INITIAL FIRE SAFETY INSPECTION REPORT

Farseeing Knit Composite Limited (Extension) _24857
RSC ID: 24857

Date: 10-Jan-2024

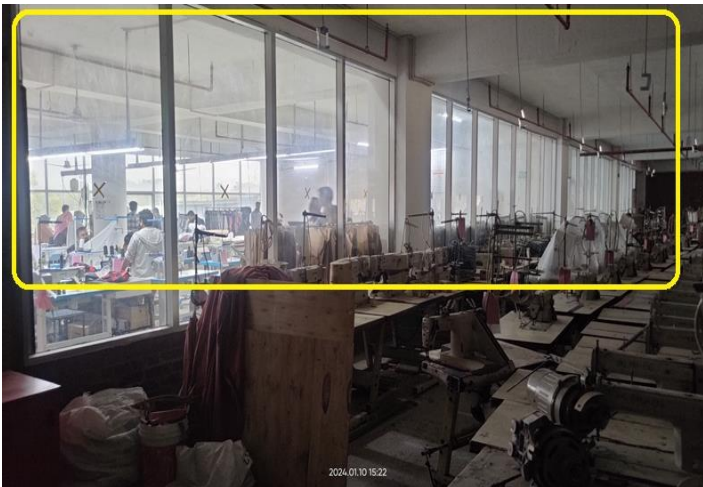
SI No.	Category	Findings	Required Action	Remediation Time Frame
F-1	Fire Rated Construction	The exit stairs are not separated from work areas, other spaces on each floor by fire-rated construction due to non-functioning door accessories, unprotected opening, non-separated water pump. Location: Main Building	Provide minimum 2-hr fire rated construction for buildings 4 storied or more and 1-hr for up to 3 storied. Seal all unprotected openings to separate the exit stairs from work areas and other spaces on all floor levels by 90 minutes for 2 hr. construction and 60 minutes for 1-hr construction. Ensure that the fire rated doors are self-closing and positive latching and that they are provided with fire exit (panic) hardware where serving production floors. If fire rated doors are required to be held open for functional reasons, provide automatic closing devices tied to the fire alarm system. Once fire doors are installed, every door in a stair enclosure serving more than 5 stories shall be provided with re-entry unless it meets.	Within 3 months

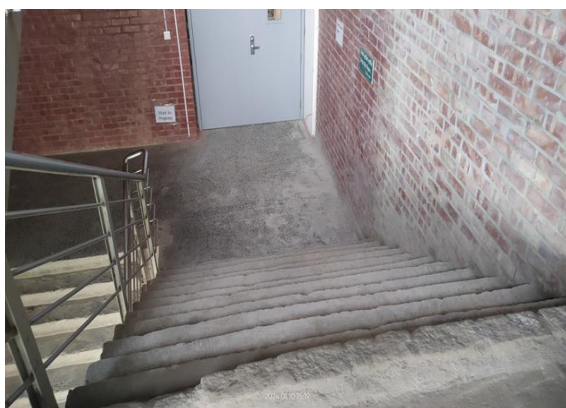
F-6	Fire Rated Construction	Areas used for combustible storage open to the factory are not separated by fire rated construction or not maintain as per standard. Location: Main Building	Separate the dedicated storage rooms by minimum 1-hr fire-rated construction. Provide 0.75 hr. fire rated door and seal all penetrations and openings by 1 hr. fire rated fire rated barrier construction. Where separate storage rooms are not feasible, provide defined storage areas and limit the storage arrangement as follows: - Maximum height of 2.45m (8ft.) , maximum area of 23m² (250 ft²) and 3m (10ft.) clear distance from adjacent another unenclosed combustible storage. - If the building/floor is sprinkler protected: maximum height of 3.66m (12ft.) and maximum area of 93m² (1000 ft²). -In process storage shall be limited to 10 percent of the building area of the story in which they occur.	Within 3 Months
-----	-------------------------	---	--	-----------------

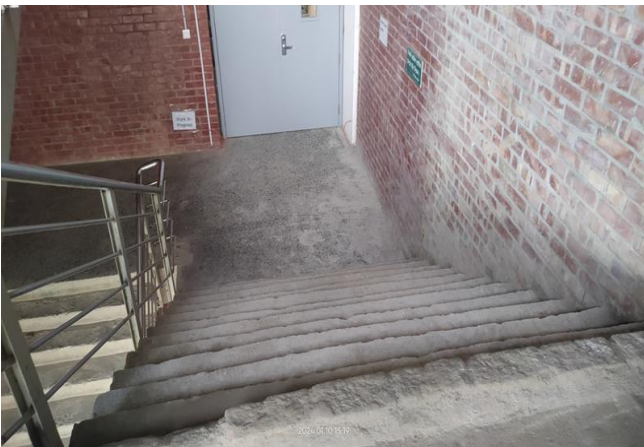
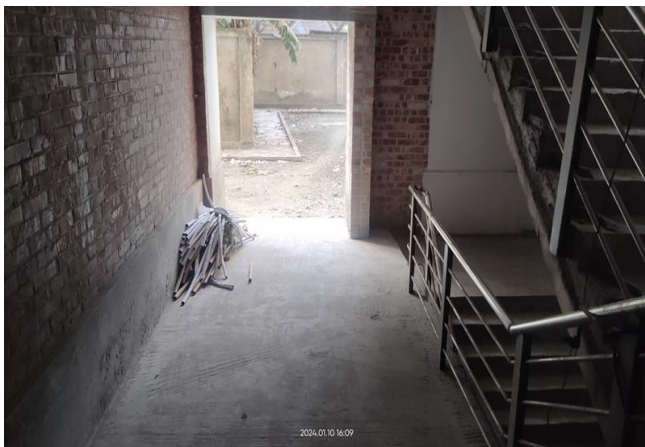
F-7	Fire Rated Construction	Office area are not fire separated from Loading-Unloading area & Production occupancy. Location: Main Building	Separate the Production area and office area by minimum 2-hr fire-rated construction from each other and Other occupancy. Provide 1.5 hr. fire rated door and seal all penetrations and openings by 2 hr. fire rated fire rated barrier construction.	Within 3 Months
-----	-------------------------	---	--	-----------------

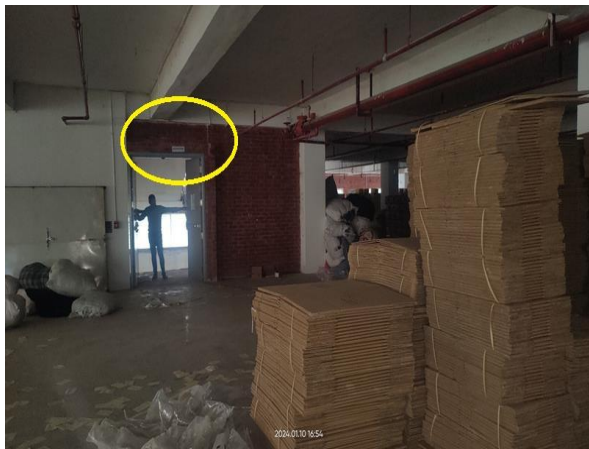
F-10	Means of Egress	Stairway treads are not uniform (throughout the building) and exit discharge path of N-E, N-W, S-W exit stair are not even & usable for all weather condition. Location: Main Building	Remove the obstructions and Provide an even level walking surface in stair & exit discharge in accordance with 6.3.4 of RSC Technical Guidelines (Standard_V1.0).	Within 3 months
------	-----------------	---	--	------------------------

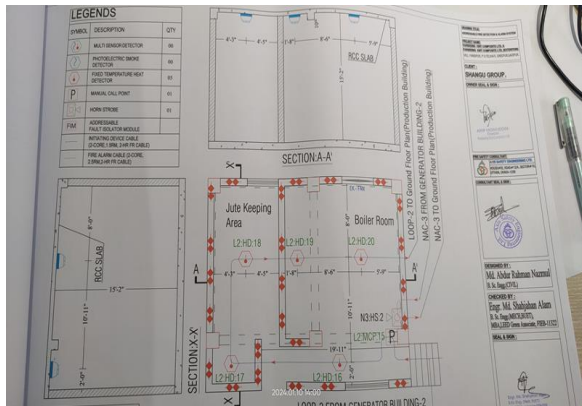
F-12	Means of Egress	Guards are not provided floor on periphery of the floor . Location: Main Building	Guards shall provide as per RSC Technical Guidelines (StandardV1.0.) Section 6.12.2 to prevent falling hazard . Minimum guard height shall be 42 in & Open guards shall have intermediate rails or pattern such that a sphere 200 mm (8 in.) in diameter cannot pass through any opening up to a height of 865 mm (34 in.).	Within 1 month
